Cable Test Requirements

**A presentation at SPI-3 working
group**

Jan.26, 1999

The purpose of this presentation is to address some concerns in the cable test requirements proposed at working group on Dec.2, 1998.

Impedance TDR Measurement

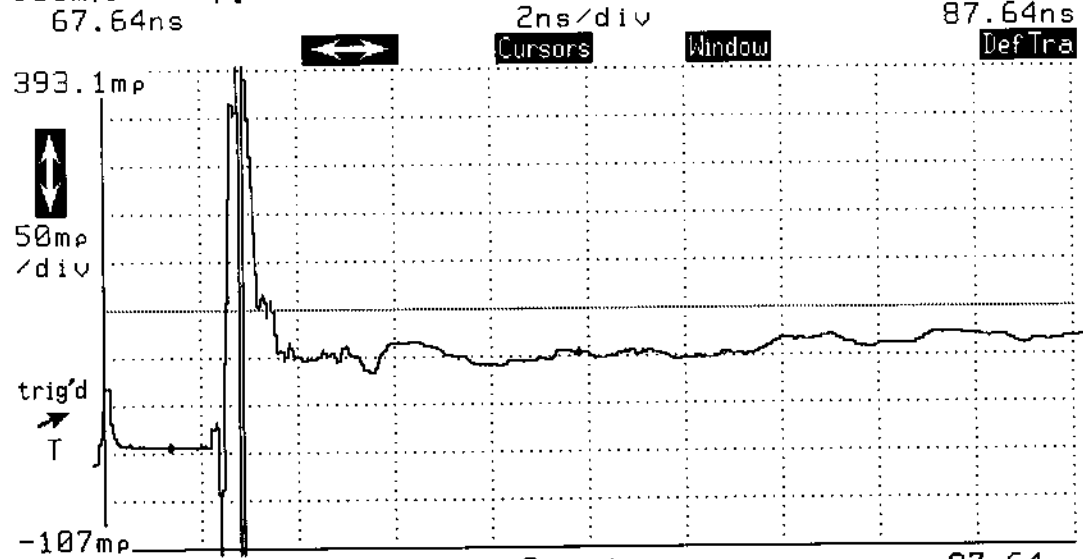
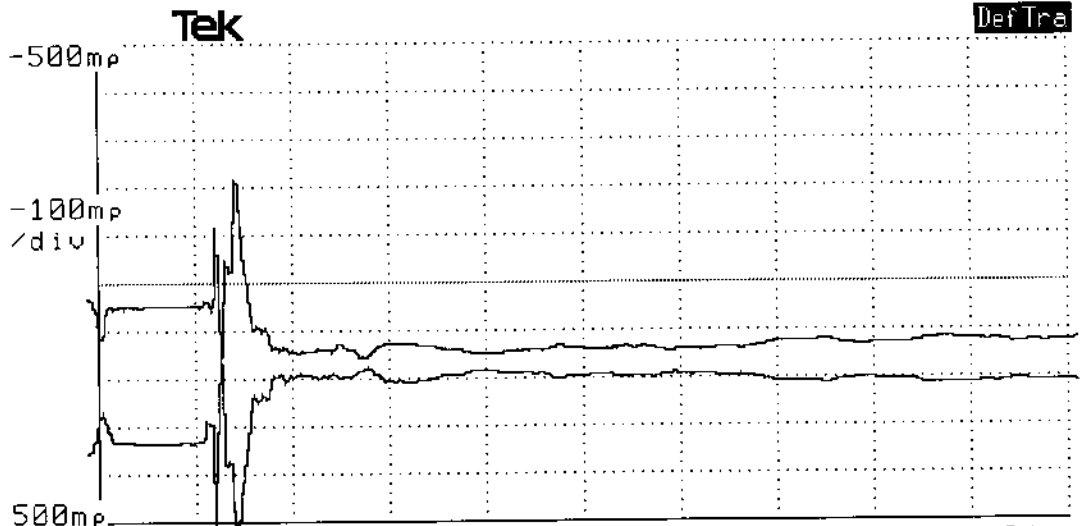
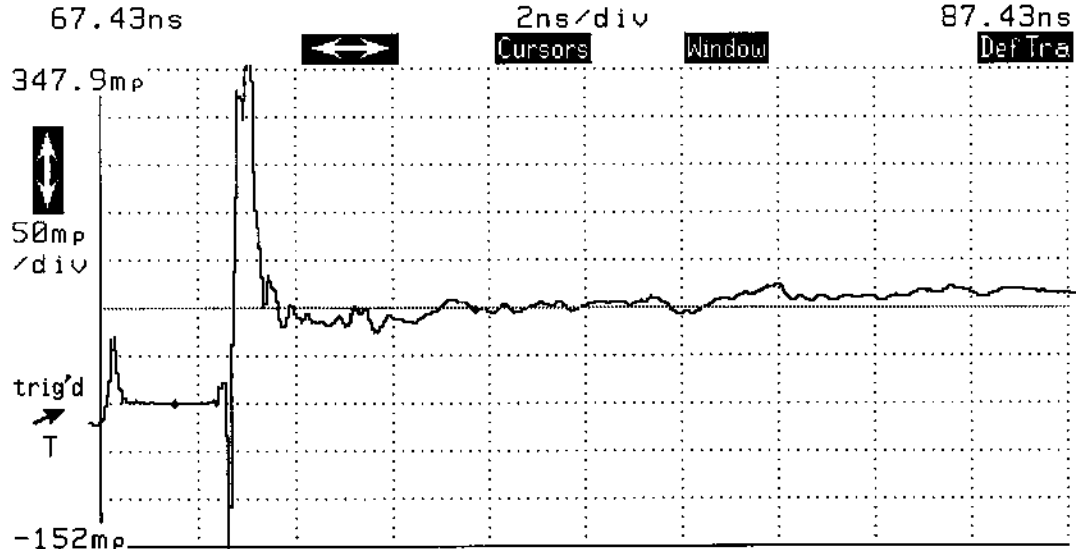
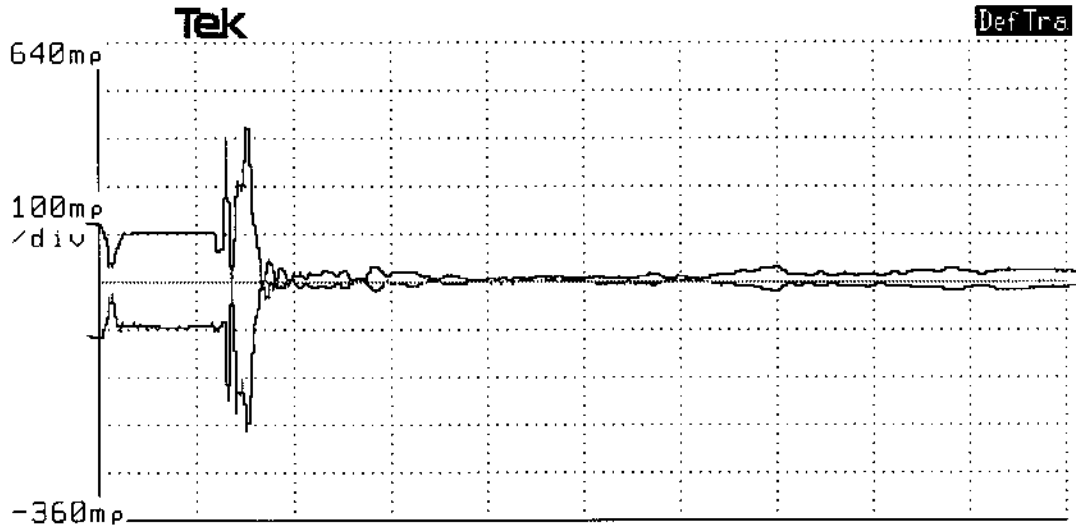
- We concern the following issues on impedance TDR measurements
 - Time Window need to be specified
 - Because @TDR, impedance is indepedant from the cable length so that the minimum testable cable length should be allowed, for example 10 ft. See attached figure for the comparision of impedance measurement on a 6 m and a 10 ft cable.
 - Rise time: we concerned 3 ns rise time is too slow for SCSI cable impedance measurement.

Attached supporting test data

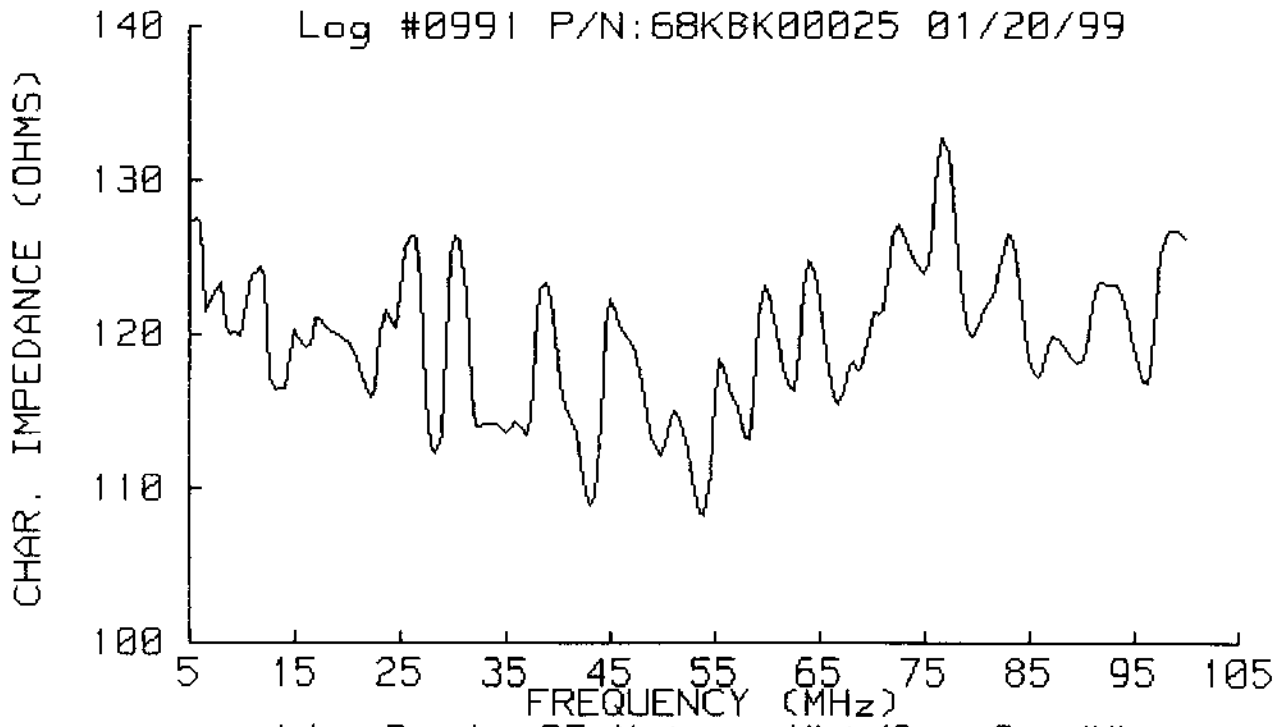
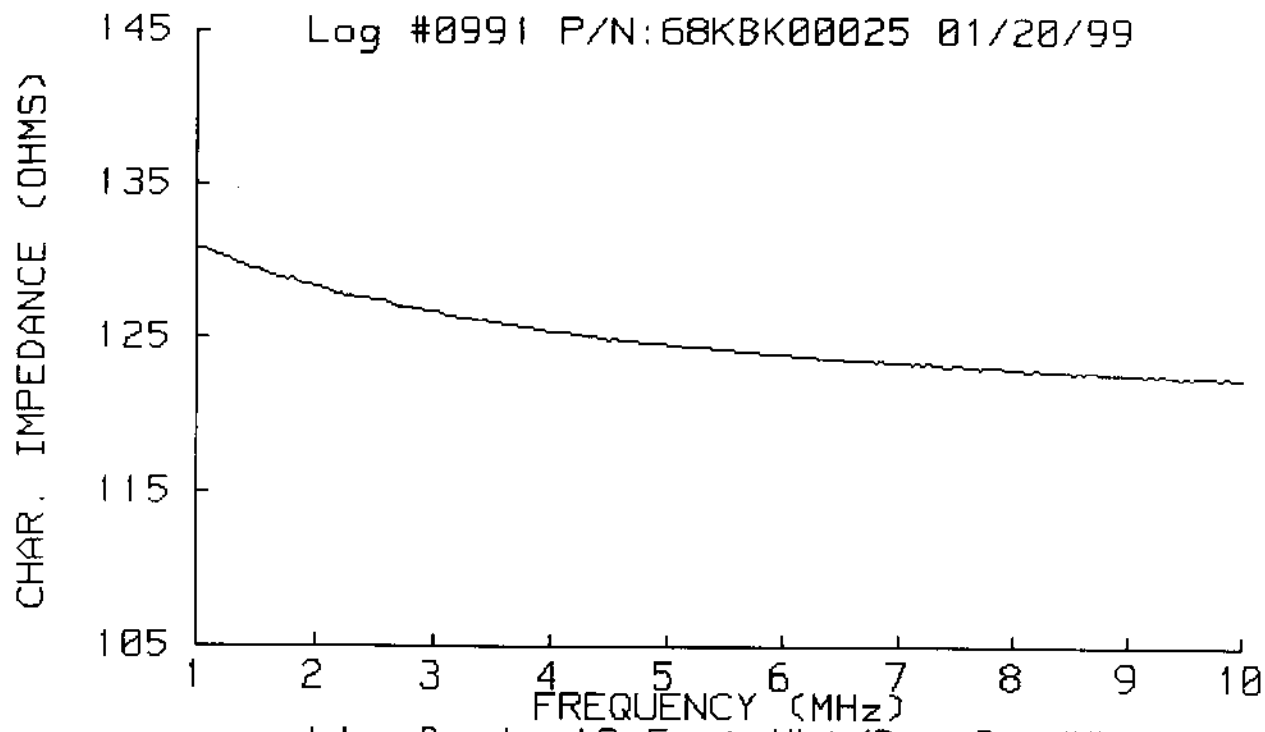
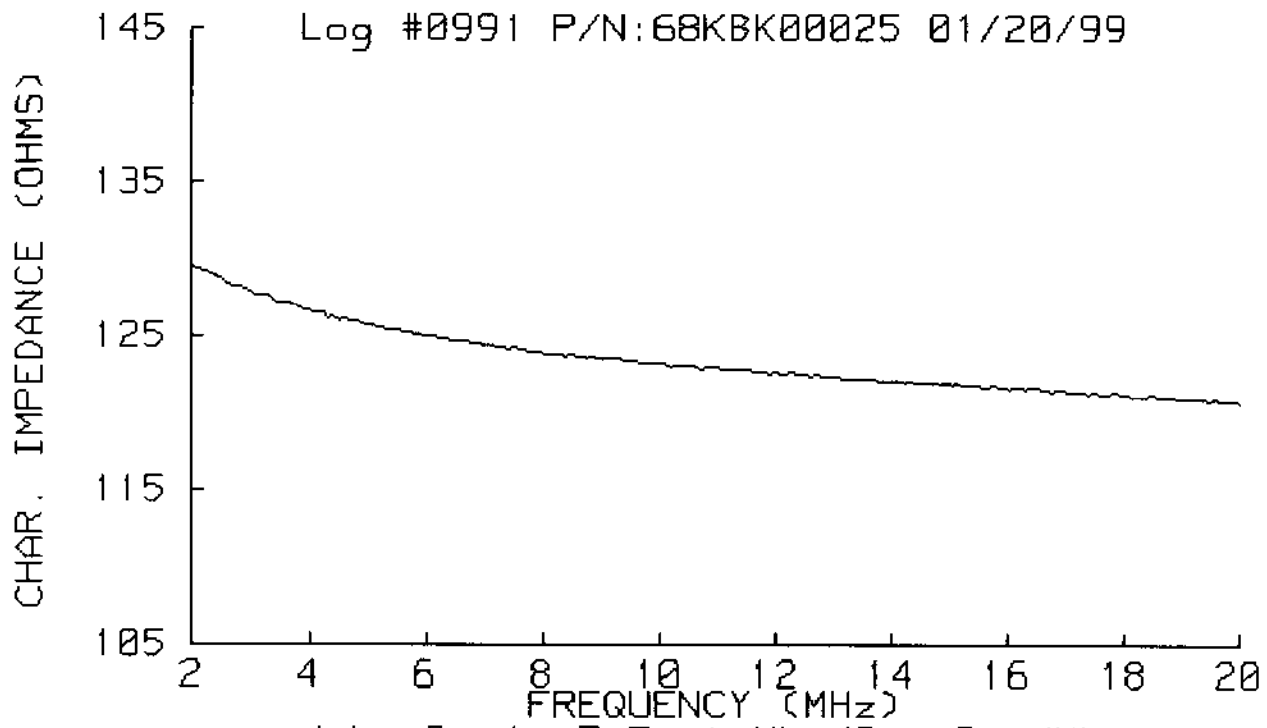
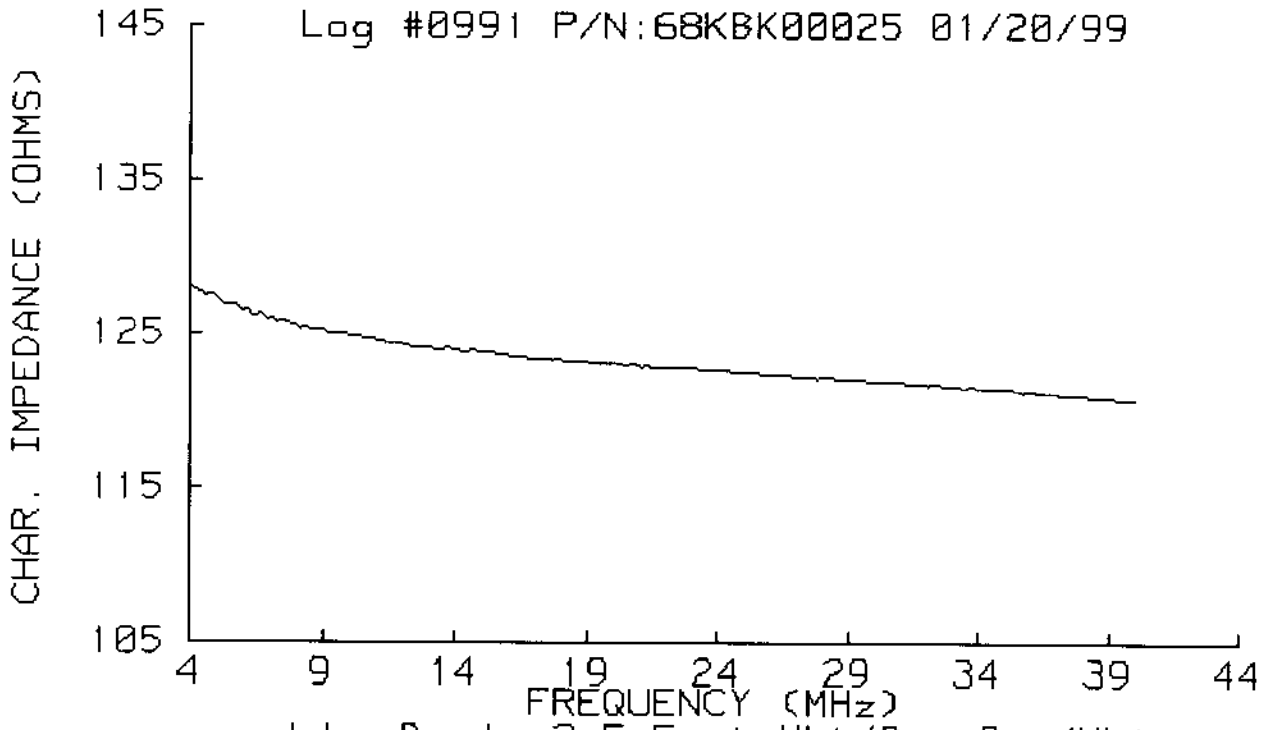
- TDR is more appropriate test method for impedance(Z) measurement on SCSI cables
 - at HF, Z is almost independent from frequency for the insulation compound used on SCSI cables
 - at LF, Z varies as frequency varies and $Z @LF$ can not be controlled separately from $Z @HF$
 - in frequency domain, Z measurement is very sensitive to the test cable length. To accurately measure Z , an optimal test length and its measureable frequency range need to be carefully calculated. For a desired wide frequency range, several cable length needed to be tested and this is not practical at production level. See attached test data.

- for a desired wide frequency range, several cable length needed to be tested and this is not practical at production level.
- There is a limit on test frequency where the test cable length is too short comparing to the test fixture that accurate Z can be measured.

Attenuation test requirements

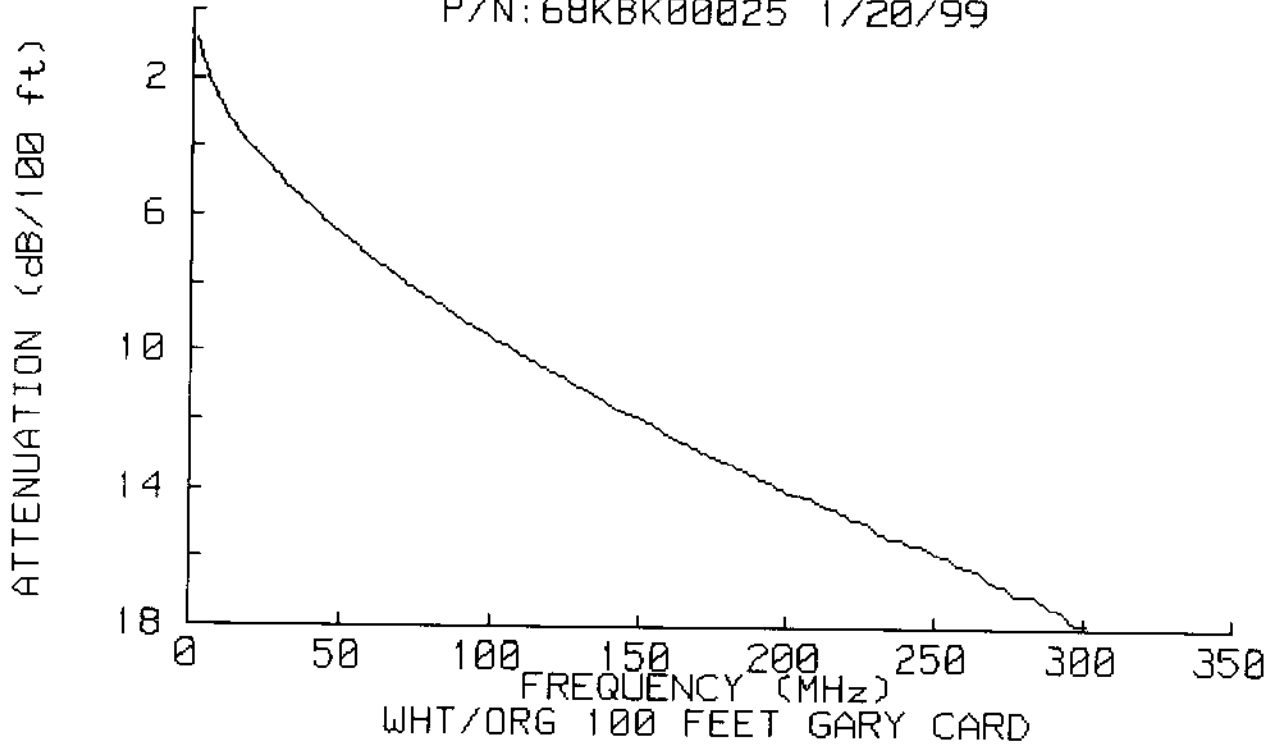
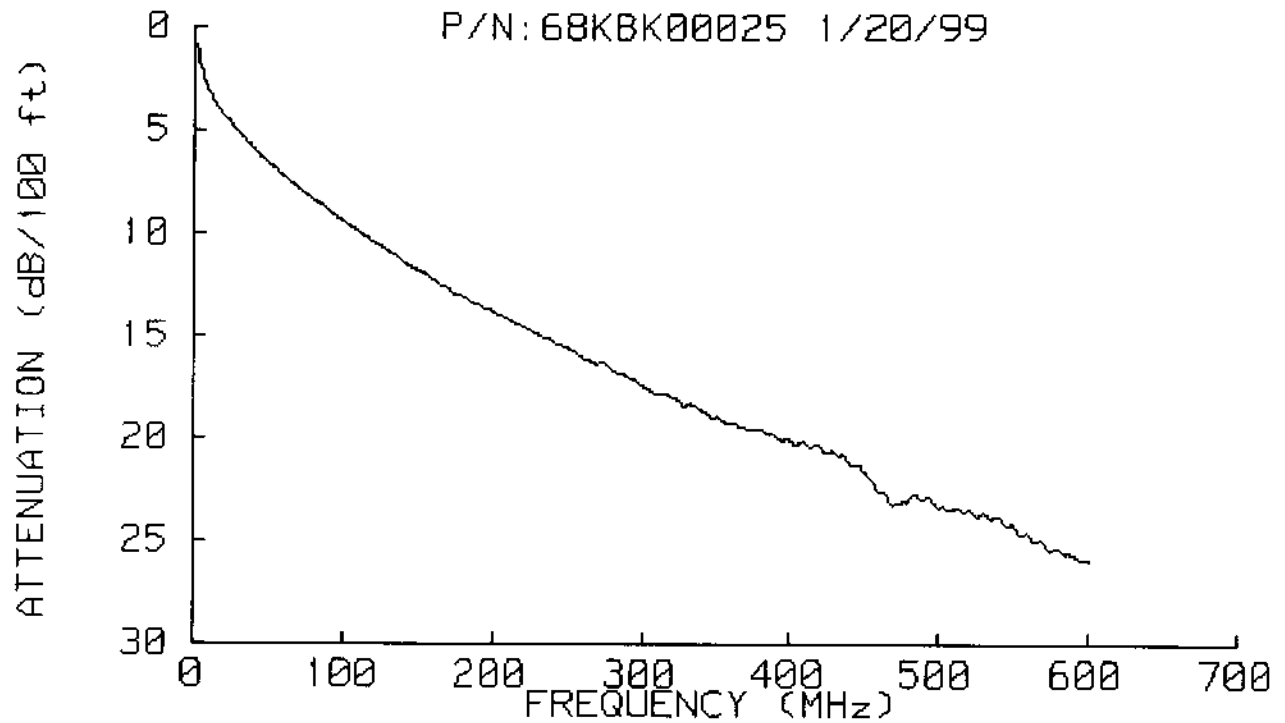
- We have two concerns:
 - 6 dB insertion loss: Based on our test data, on one given cable length, it is not practical to set this requirement. We propose to remove this requirement.
 - Required test frequency range: It will be very difficult to measure the attenuation at very high frequency due to fixture limit. We propose 1 MHz to 600 MHz and would like to see some actual test data from other manufacturers and to discuss the more practical test range.
